OHIO TURNPIKE AND
INFRASTRUCTURE COMMISSION

ADDENDUM NO. 3

PROJECT NO. 39-16-01 (PART A)
RIGHT TWO (2) LANES AND SHOULDER RECONSTRUCTION
MILEPOST 107.3 TO MILEPOST 112.5
ERIE COUNTY, OHIO

PROJECT NO. 39-16-01 (PART B)
BRIDGE DECK REPAIR & REHABILITATION
OHIO TURNPIKE OVER NS RAILROAD AND KELLY ROAD MILEPOST 117.3
OHIO TURNPIKE OVER US ROUTE 250 MILEPOST 118.1
ERIE COUNTY, OHIO

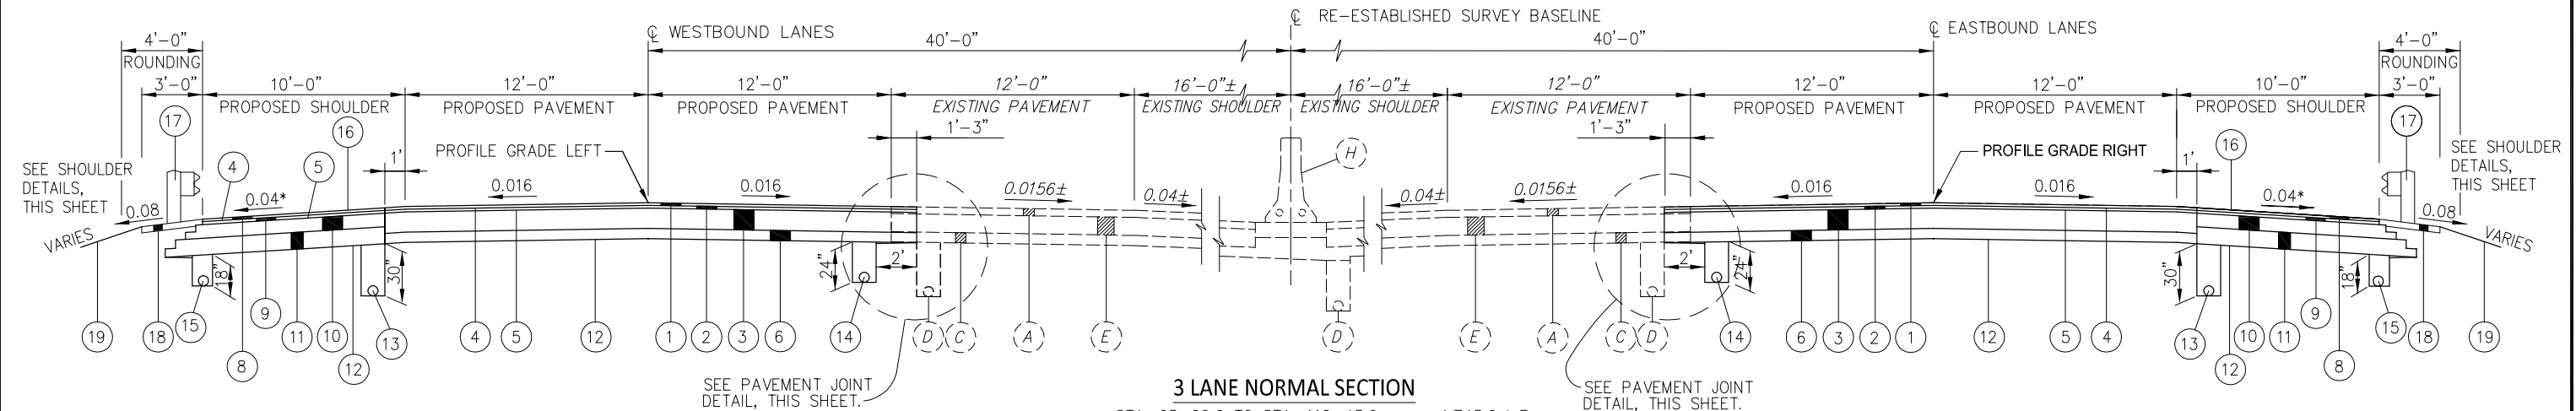
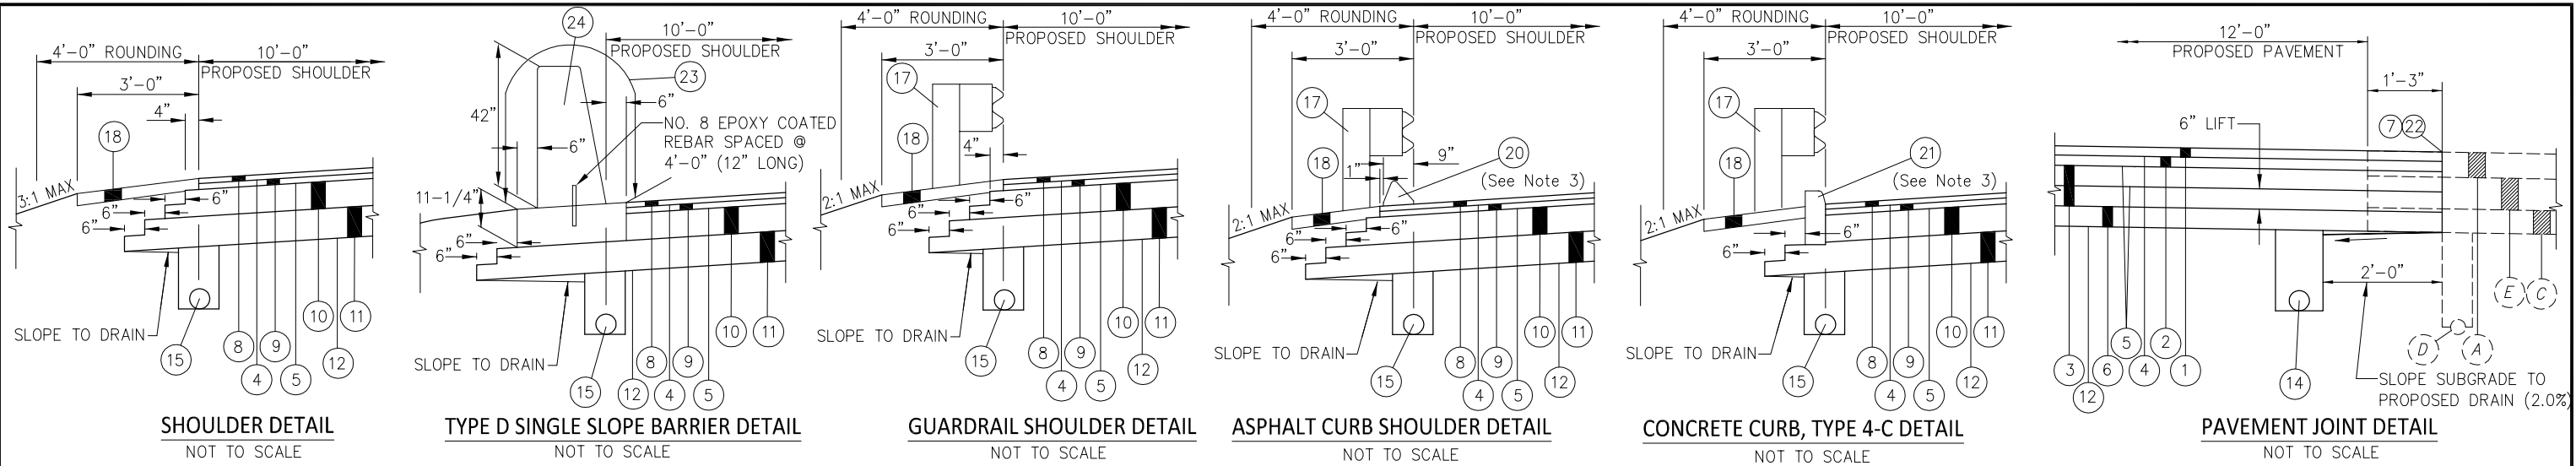
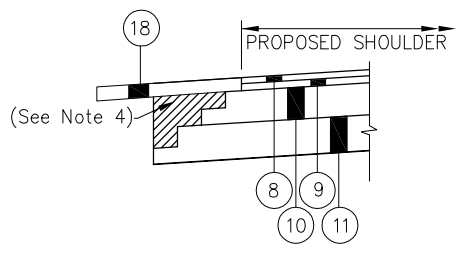
Q#22 **Bid item 117- Joint Sealer (SP 404A)- the pavement joint detail on plan sheet 6 shows legend item 22 (SP 404A) as joint sealer “applied to vertical face, each lift”. This would be a total of four lifts per directional joint. In addition this is called for the crossover restorations (1 lift) shown on sheet 329 as well as resurfacing of median shoulders (1 lift, against the median barrier and the existing pavement) as shown on plan sheet 13. We believe that the owner quantity is understated based on these details. We feel that based on these conditions that the owner quantity is incorrectly understated. Please review and revise the quantity and/or clarify that the contractor gets paid per foot per lift given the different depths of pavement joints.**

A#22 *This Addendum No. 3 revises Item 22 – Joint Sealer on Plan Sheets 6 and 9 of 432 to read “applied to vertical face”.*

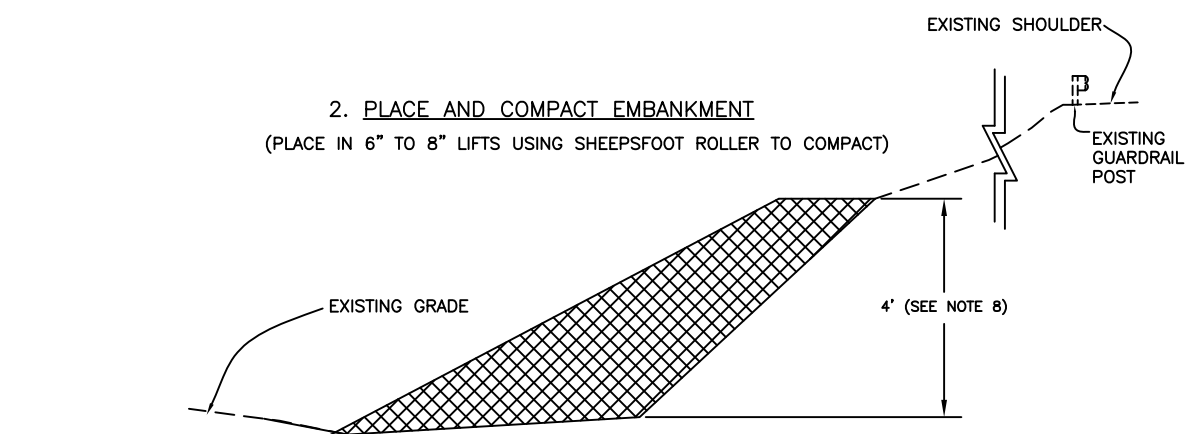
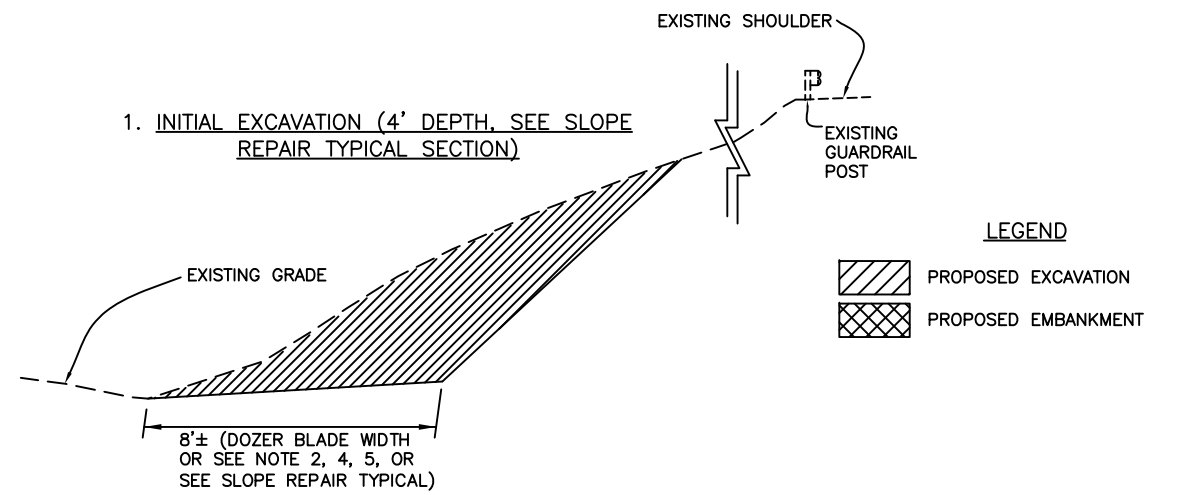
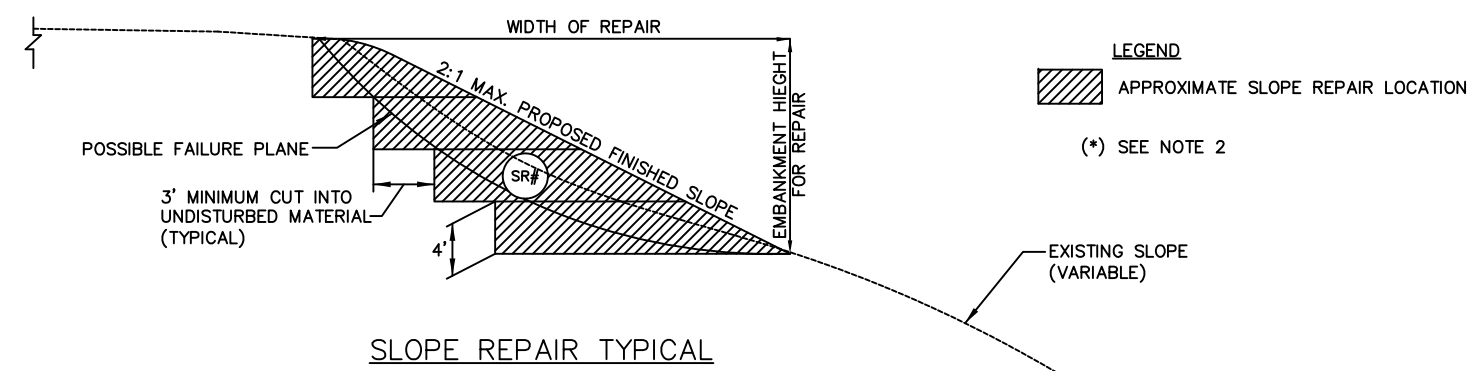
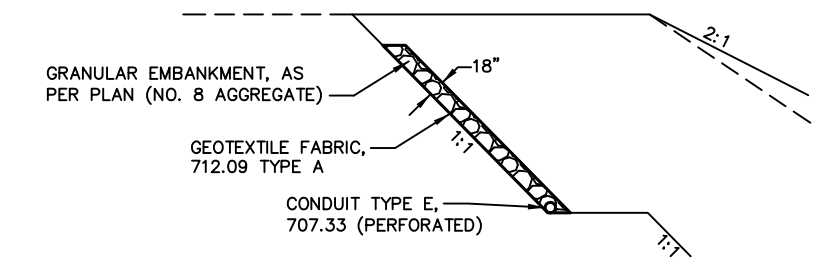
Q#28 Bid item #53- Limestone Sand, 2500 CY: slope repair sheet 1 calls for 10% incorporation of limestone sand into embankments in note 3. Note 12 also calls for a contingency of 2500 cy in case mixed dirt doesn’t meet specifications. Is the volume of sand in the 10% incorporation included as part of the 2500 cubic yards?

Q#29 Bid item #53- Limestone Sand, 2500 CY: this quantity seems to be overstated given the amount of excavation and borrow called for in the three areas of slope repair. Please review this plan quantity and if necessary revise.

A#28 *The inclusion of the limestone sand is only where it is required for stability and the quantity of Item Special - Limestone Sand is provided as the estimated amount to meet the requirements of Note 10 and 12 on Plan Insert Sheet 1 of 1.*

A#29 *This Addendum No. 3 revises the quantity of Item Special – Limestone Sand in Note 12 on Plan Insert Sheet 1 of 1, General Summary on Plan Sheet 216 of 432 and the Bid Schedule Ref. No. 53 to reflect 225 CY.*
